ZONING BOARD OF ADJUSTMENT, PANEL A
TUESDAY, FEBRUARY 19, 2019
AGENDA

FILE NUMBER: BDA189-013(SL)

LOCATION: 1475 McKee Street

Driveway set back

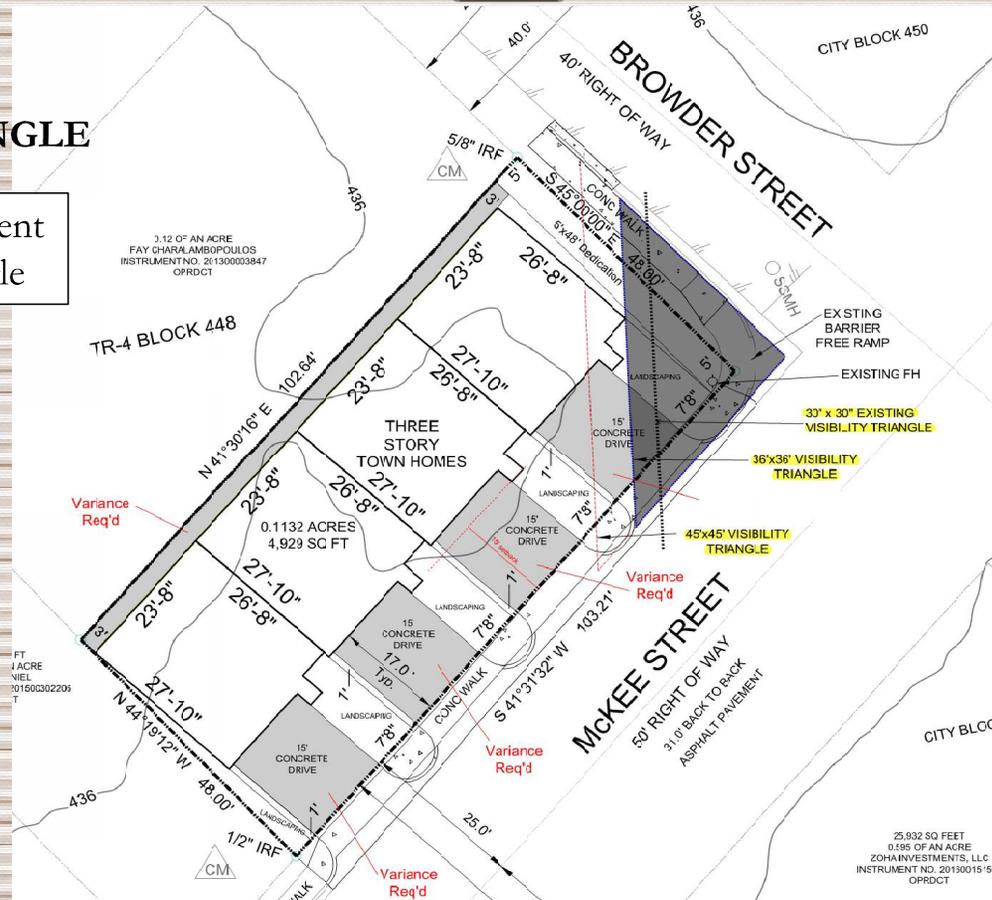
- **20' driveway set back**
 - City Traffic Engineer concedes the 17' driveway + 18' deep garage is sufficient for (4) off street parking spaces
 - Required because of the rear setback

Driveway set back

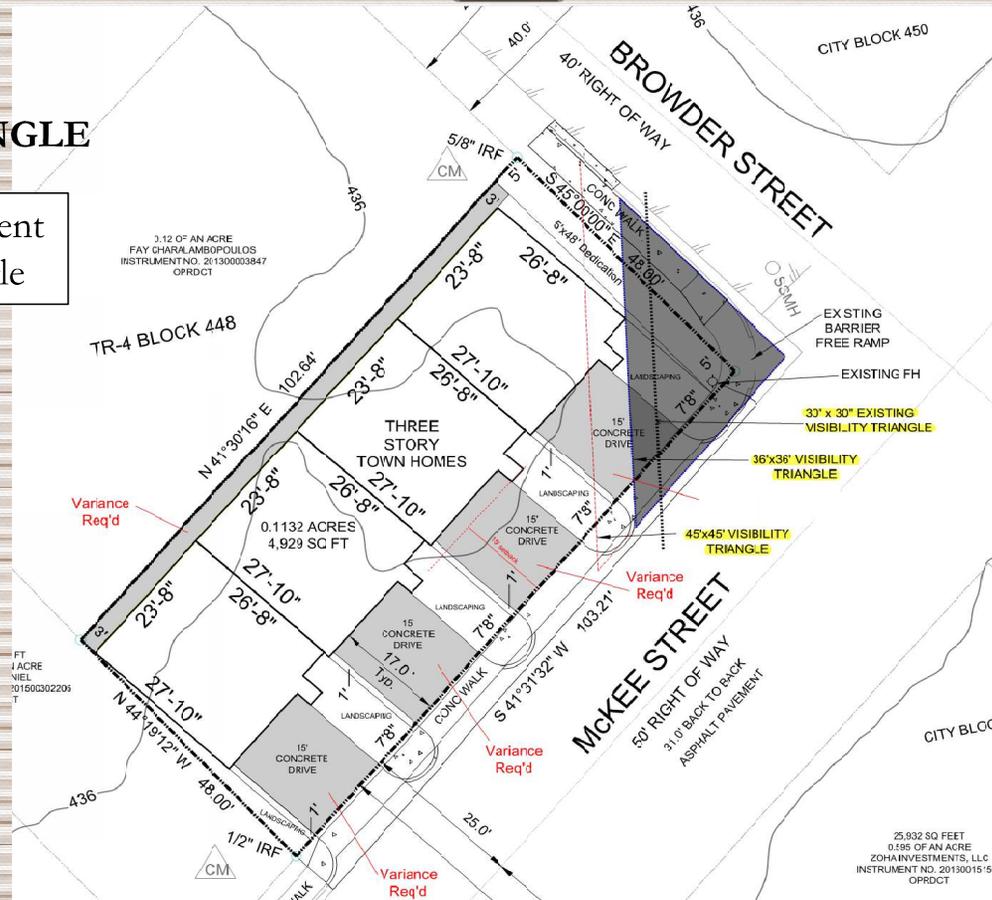
- **20' driveway set back**
 - City Traffic Engineer concedes the 17' driveway + 18' deep garage is sufficient for (4) off street parking spaces
 - Required because of the rear setback

Driveway set back

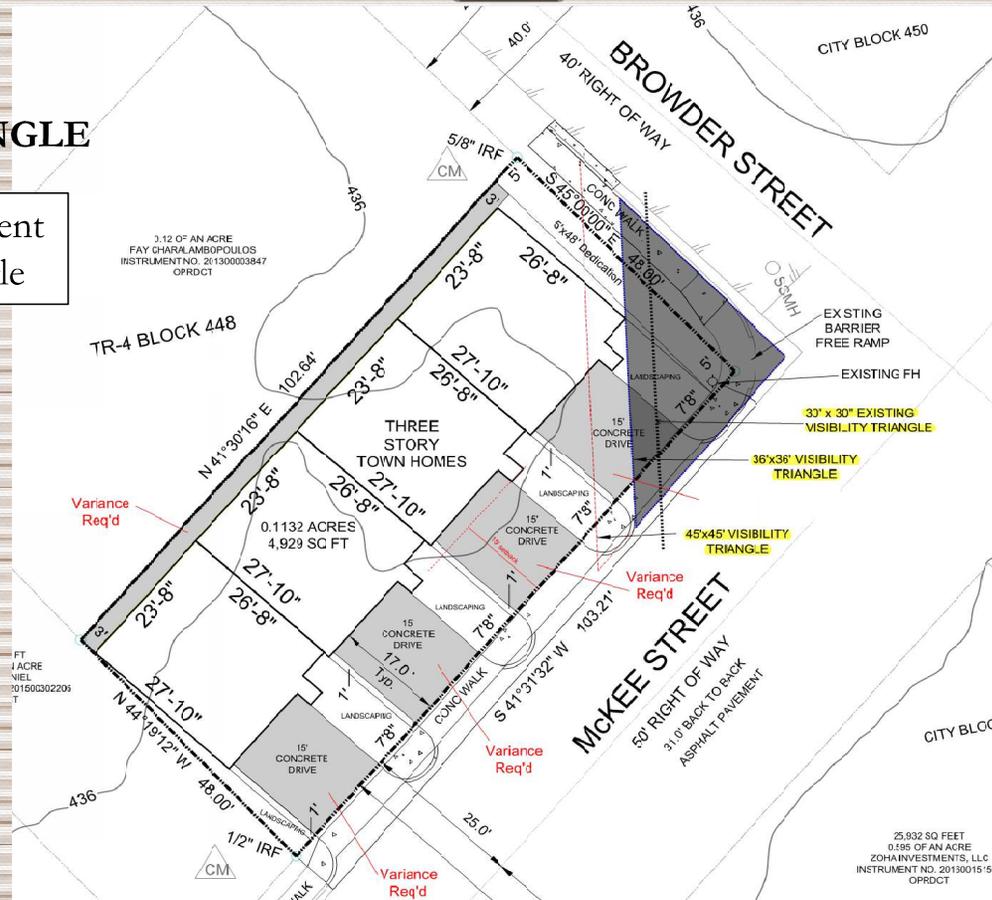
- **20' driveway set back**
 - City Traffic Engineer concedes the 17' driveway + 18' deep garage is sufficient for (4) off street parking spaces
 - Required because of the rear setback

Driveway set back

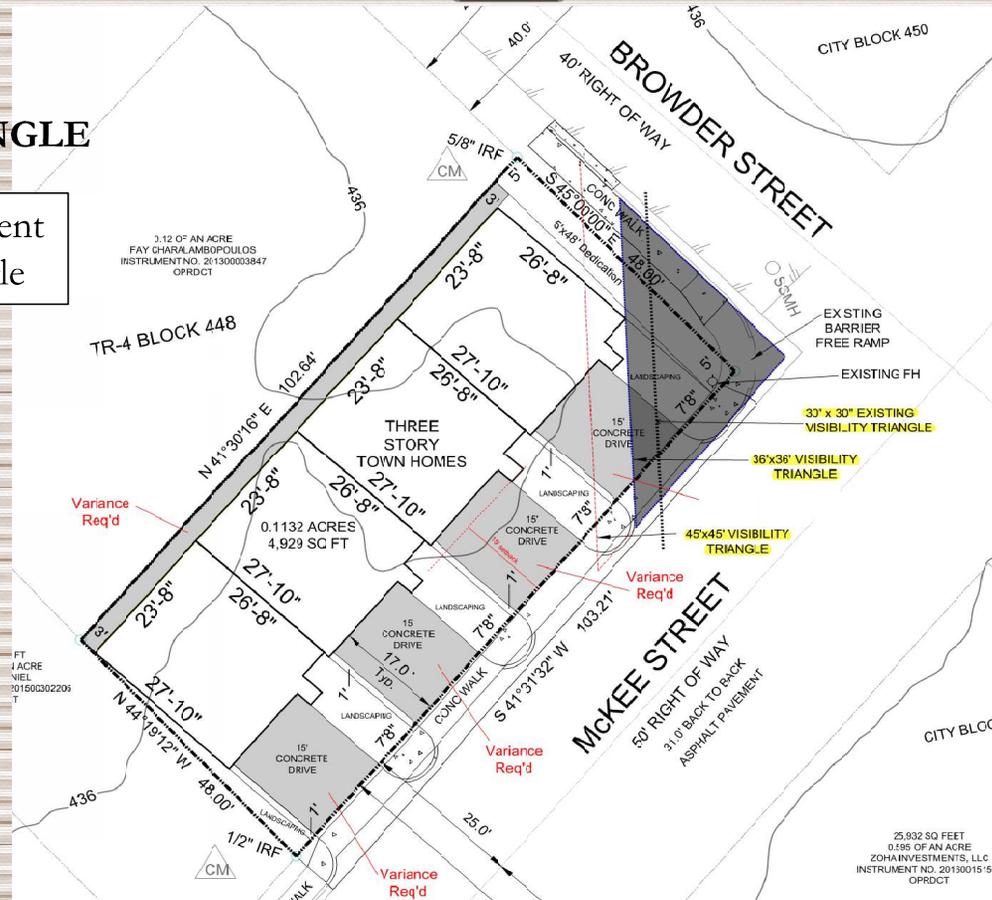
- **20' driveway set back**
 - City Traffic Engineer concedes the 17' driveway + 18' deep garage is sufficient for (4) off street parking spaces
 - Required because of the rear setback
